ADDENDUM NO. 4 TO PROJECT NO. Q0763-C

**ASBESTOS REMOVAL, DEMOLITION
AND REPLACE WINDOWS
DUNLAP BUILDING NO. 102, A-SIDE
MANHATTAN PSYCHIATRIC CENTER
600 E. 125th STREET
WARDS ISLAND, NEW YORK**

January 02, 2013

FINAL	10/3/2012	BID DOCUMENT
DATE		
MARK		
PROJECT NUMBER	Q0763	C
DESIGNED BY:	DWM	
DRAWN BY:	SL DWM	
FIELD CHECK:	SL DWM	
APPROVED:	DWM	
SHEET TITLE:	FIRST FLOOR DEMOLITION AND WINDOW INSTALLATION PLAN	
DRAWING NUMBER:	A-102	
SHEET	28	OF 56

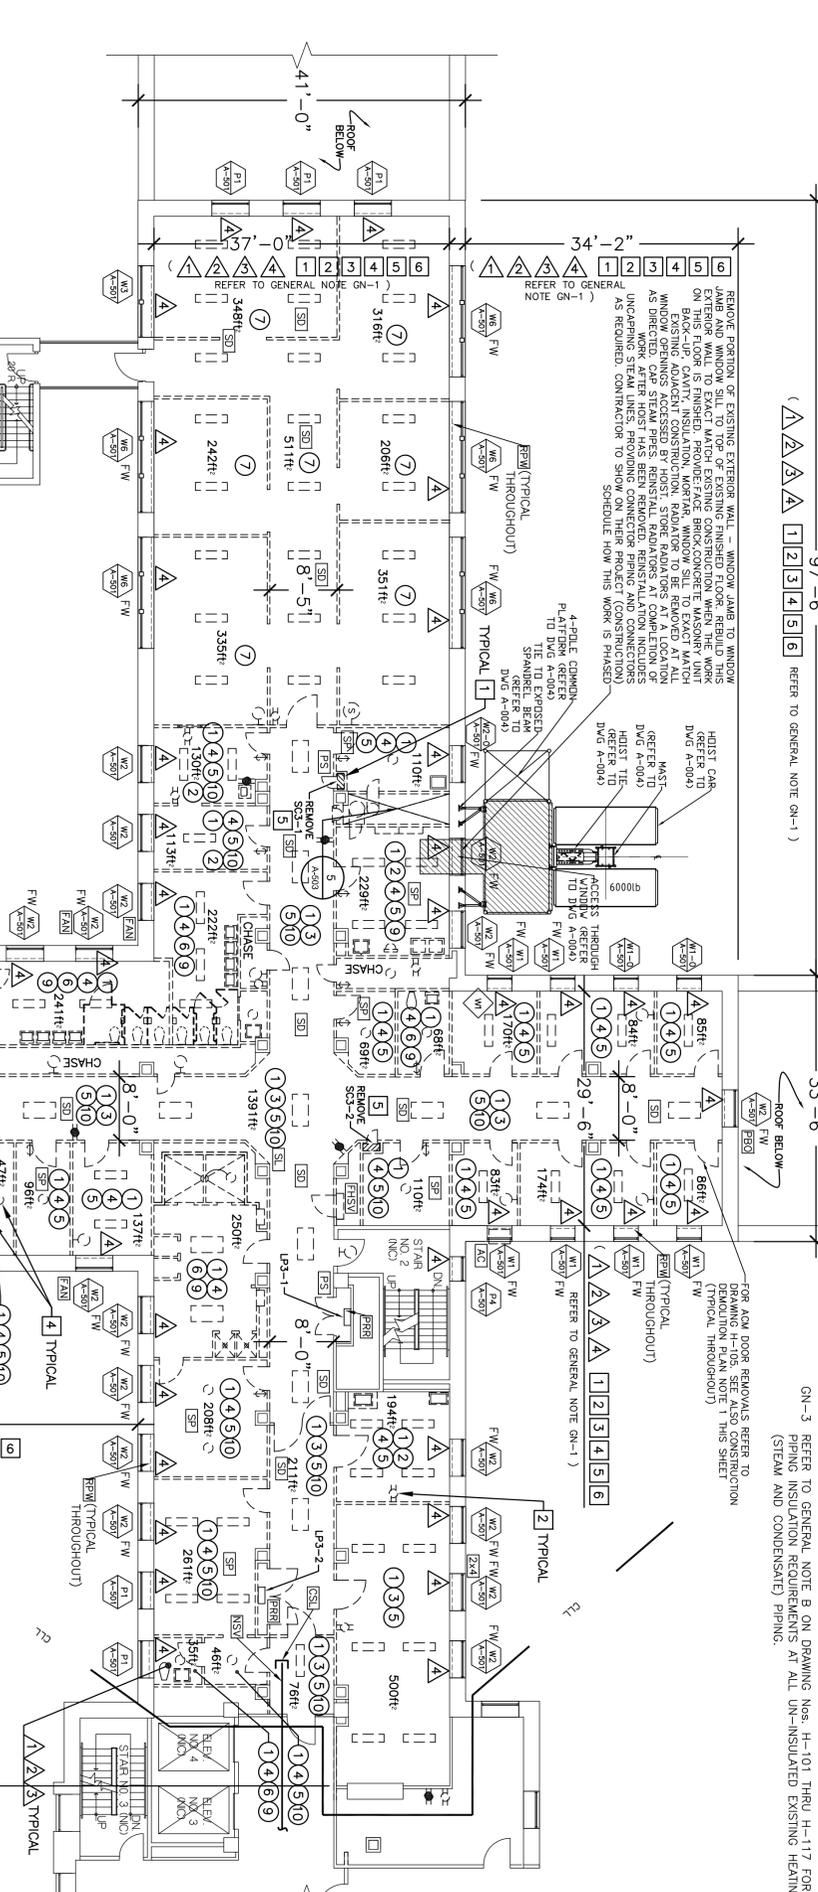
- 5) Eleventh (11th) floor thru Sixteenth (16th) floors: Do not disturb any of the existing fire alarm system components.”
7. Drawing Nos. A-101, A-102, A-103, A-104, A-105, A-106, A-107, A-108, A-109, A-110, A-111, A-112, A-113, A-114, A-115, A-116, and A-117 – ALL drawings “REVISED DRAWING 12/26/2012” that accompany this Addendum: Add the following General Notes to ALL the aforementioned drawings:

“GN-4. Plumbing: The contractor is advised that none of the existing valves on plumbing mains, risers or floor branches are in operable condition. Prior to the start of demolition, the contractor shall provide sectionalizing valves on the sub-basement water mains to isolate the entire “A” side from the Center and “B” sides. Valves will be required on the following plumbing mains: 3” High HW, 1½” High Circ, 4”

Mid CW, 3" Mid HW, 1½" Mid Circ, 4" Low CW, 3" Low HW, 1½" Low Circ and 1" Gas (not used) before the first riser take-offs. This work will require a full building shut down, must be coordinated with the facility and will be required to be performed on off- hours (between 7:30pm and 7:00am). After the main valves are installed and the "A" side has been isolated, the contractor will be required to provide additional isolation valves as necessary for the purposes of re-activating any water risers that will be needed to supply temporary water for construction and temporary toilet use."
